# SoLID Collaboration Meeting

## Magnet & Infrastructure Support

# Director's Review Comments - Technical

5 gauss boundary of CLEO coil on support stand – 200A  
TOSCA model run by Steve Lassiter

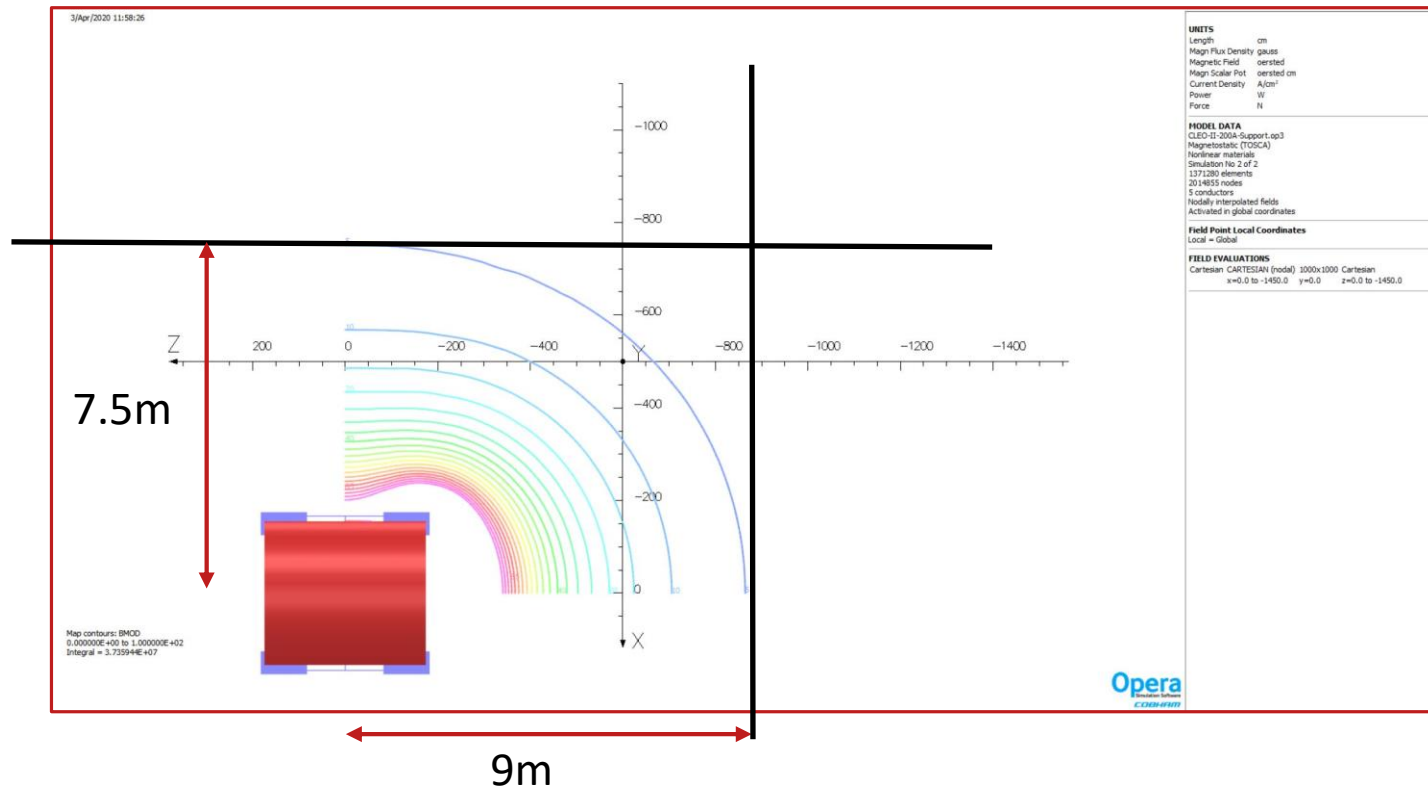
- It is essential that a careful magnetic analysis be performed of the SOLID Solenoid cold low current test configuration in the Test Lab and the 50 gauss and 5 gauss field boundaries clearly identified. It may be possible to optimize the SOLID Solenoid test location within the Test Lab to minimize magnetic effects on adjacent magnetically sensitive equipment and occupied areas. The magnetic field boundaries must be measured during the SOLID Solenoid low current testing and the 50 gauss boundary, 5 gauss boundary and maybe even a lower magnetic boundary measured and posted.

- Analysis completed to identify 5 and 50 gauss boundary. Other stakeholders in the test lab are in the loop to provide coordination for testing.
- Develop the magnetic magnet measurement specification (resolution, precision...) – so the testing activity can be adequately planned for and costed. Resolve inconsistency between costed magnet measurement set-up (50k) and number stated in the pre-CDR (200k).
